PARISH COUNCIL BRIEFING FOR ONLINE PLANNING MEETING ON 15 FEBRUARY 2021

20/03631/S73 - Glendale, Fivehead, TA3 6PD

Application to vary conditions 02, 03, 04, 05, 06, 07, 08, 10 of approval 18/01855/FUL (Demolition of existing dwelling and the erection 3 No. new dwellings), as varied by approval 19/02672/S73, to allow change to siting of the three dwellings, minor changes to internal layout and elevations and amended landscaping scheme.

Fig. 1

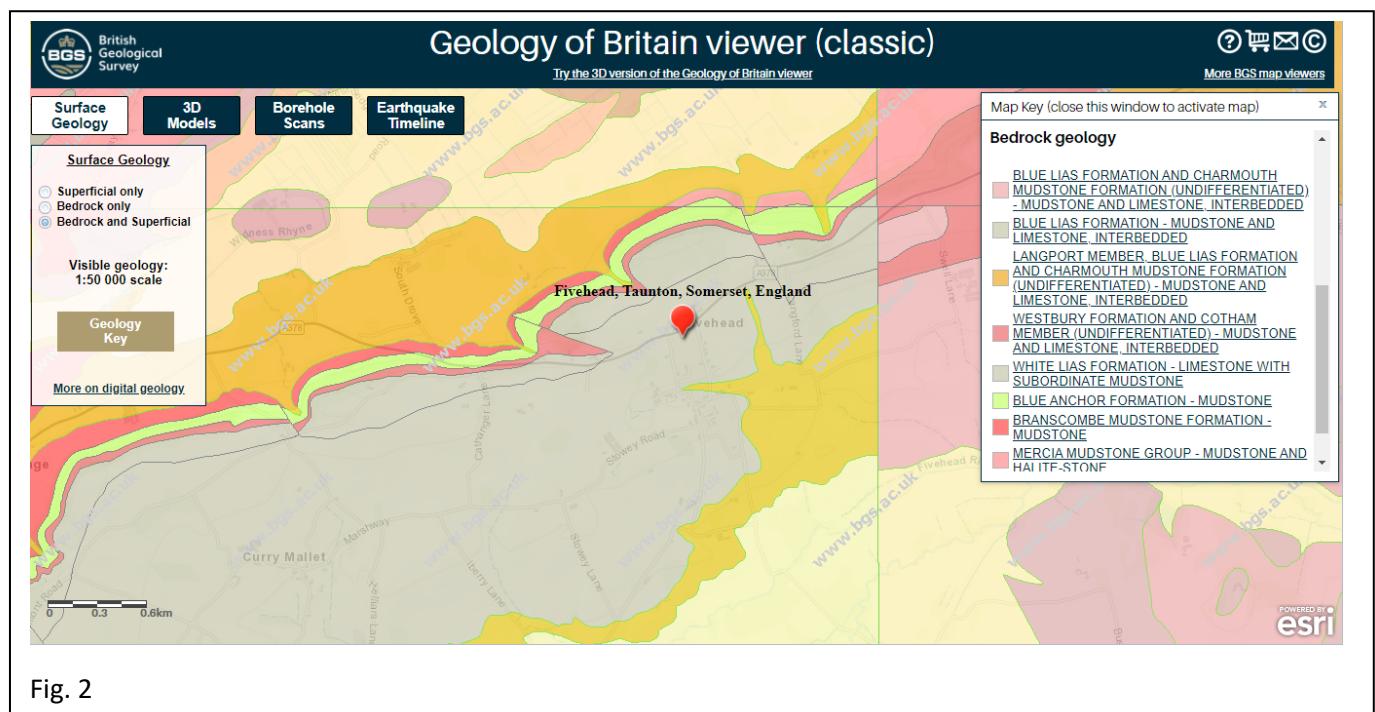
Drawing DSGN0087_SK_2-P05 (18/01855/FUL) submitted with the first application, shows the houses 'cut' into the hillside and sitting below the treeline of the environment beyond. (Fig. 1) The previous approvals given by the Parish Council were based on the plans submitted with 18/01855/FUL and 19/02672/S7, all without measurements, but on the understanding the development would remain a woodland with the houses not visible within.

- Why has Plot 1 risen to such an extent?
- Will the other Plots be elevated?
- Has the change in height and position been prompted by the bedrock layer making insertion of the piles in the original location impossible?
- Were the heights of the houses specifically agreed with SSDC, if so, can the Parish Council view these plans?
- Did SSDC agree to abandoning the 'no-dig' method, the Landscape and Tree Plans setting out the entire site as a Root Protection Area (RPA)?

Fig. 2

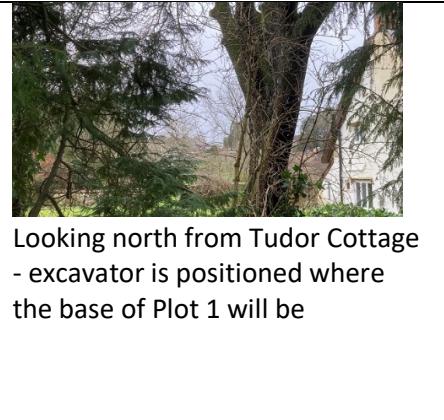
It is also noted the site sits on a bedrock plateau consisting blue/white lias. (Fig 2) The construction method for this site is for the houses to sit on piles with a no-dig method to avoid disturbance to the Root Protection Area (RPA), constituting the entire site, for the trees which were to remain.
